T-068 SERVICE BULLETIN

Two Piece Diffuser Installation Rework Instructions

Engine Application(s):	Rolls - Royce Allison 250-C40B, C47B, C47M
Subject:	Rework of Compressor Rear Mount for Installation of PMA Part
Compliance:	Customer option.
Revisions:	N/C Dated: 3/25/04 Initial release
	A Dated: 9/22/04 Removed rework of support
	B Dated: 9/24/04 Updated subject line, part numbers 23055455 or 23064593 in Figure 2 were 23007196.
	C Dated: 8/25/09 Updated EXTEX to TIMKEN.
	D Dated: 2/04/16 Updated Timken to EXTEX Engineered Products.

FIGURE 1

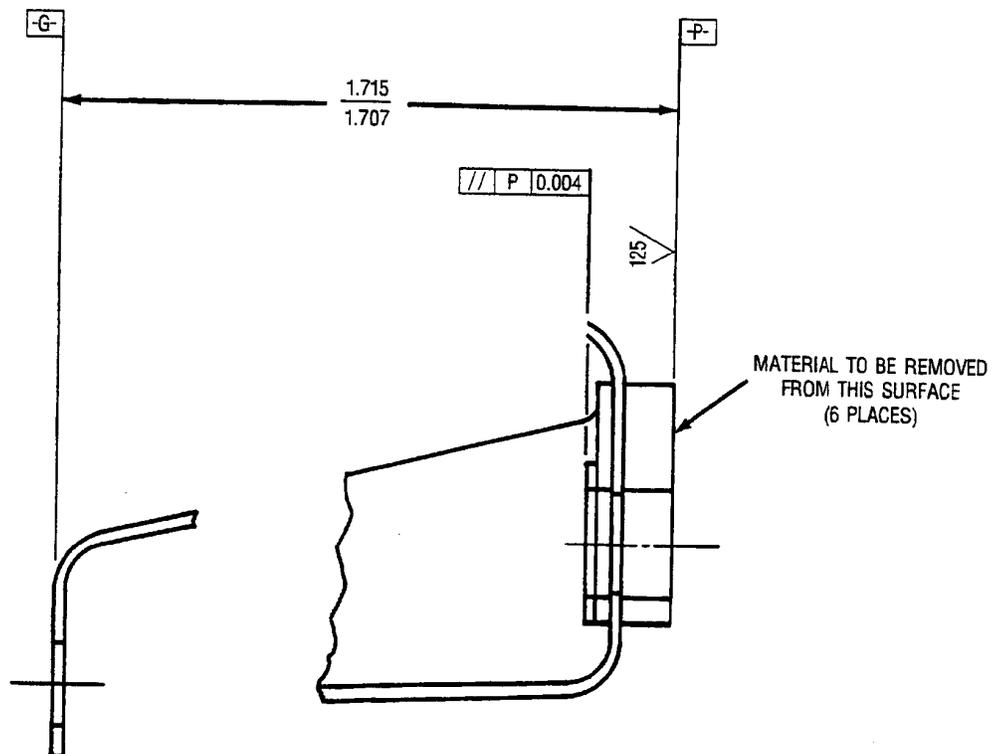
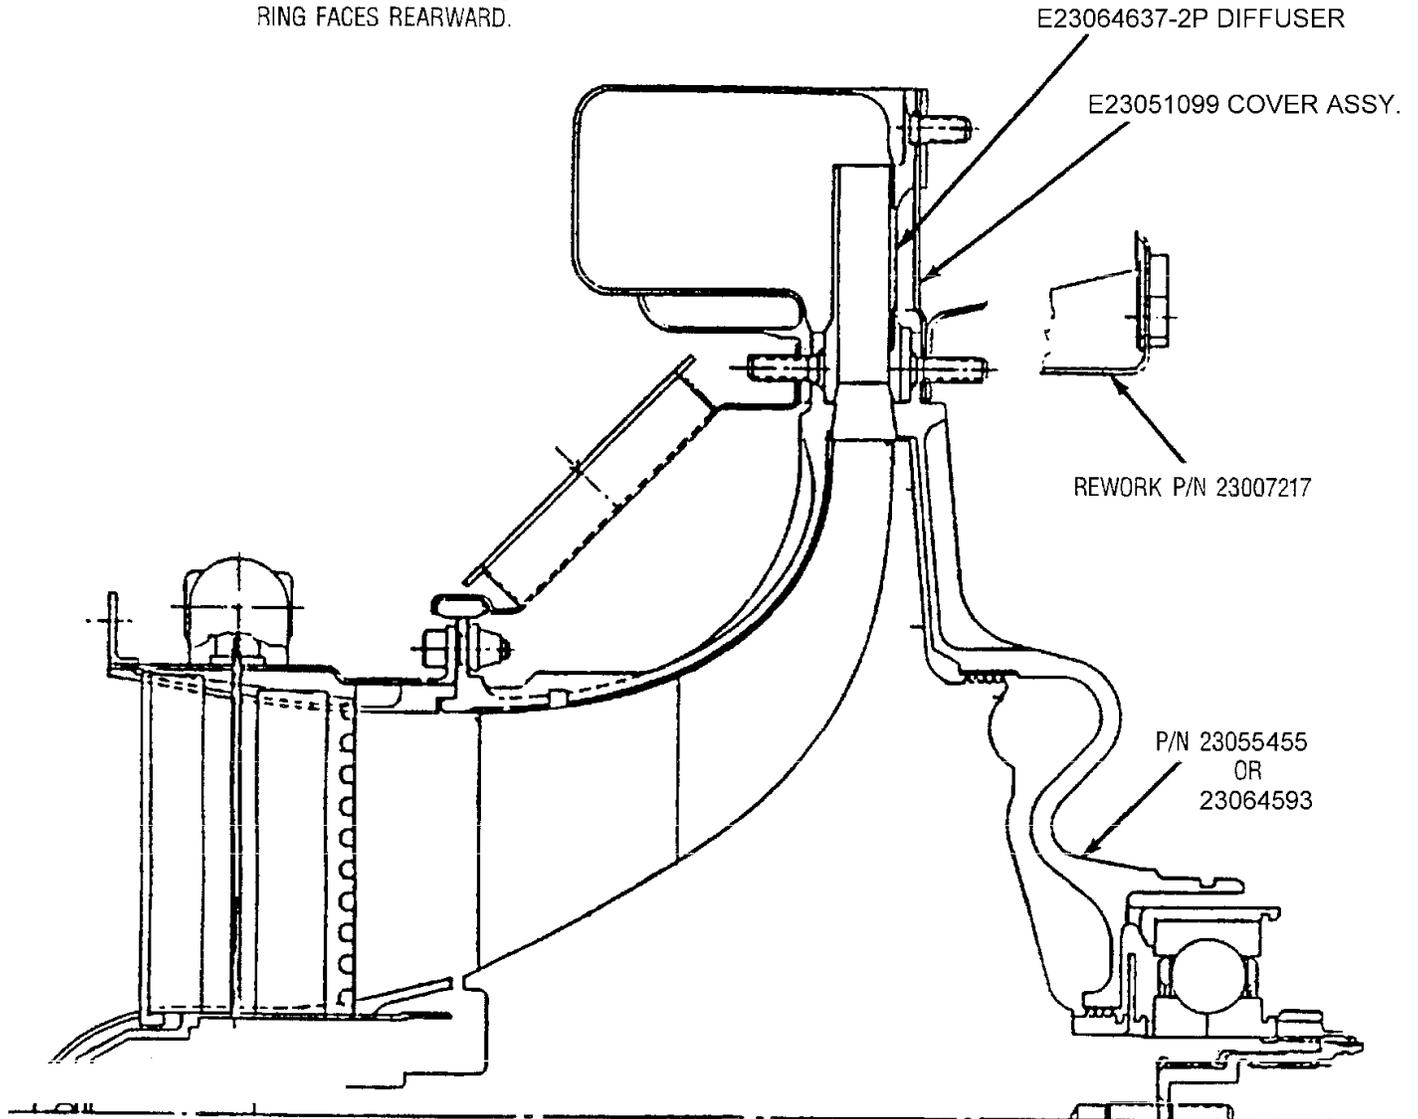
- Rework Rear Mount as shown in Figure 1 and re-identify with "reworked per Extex T-068" vibropeened immediately following P/N.
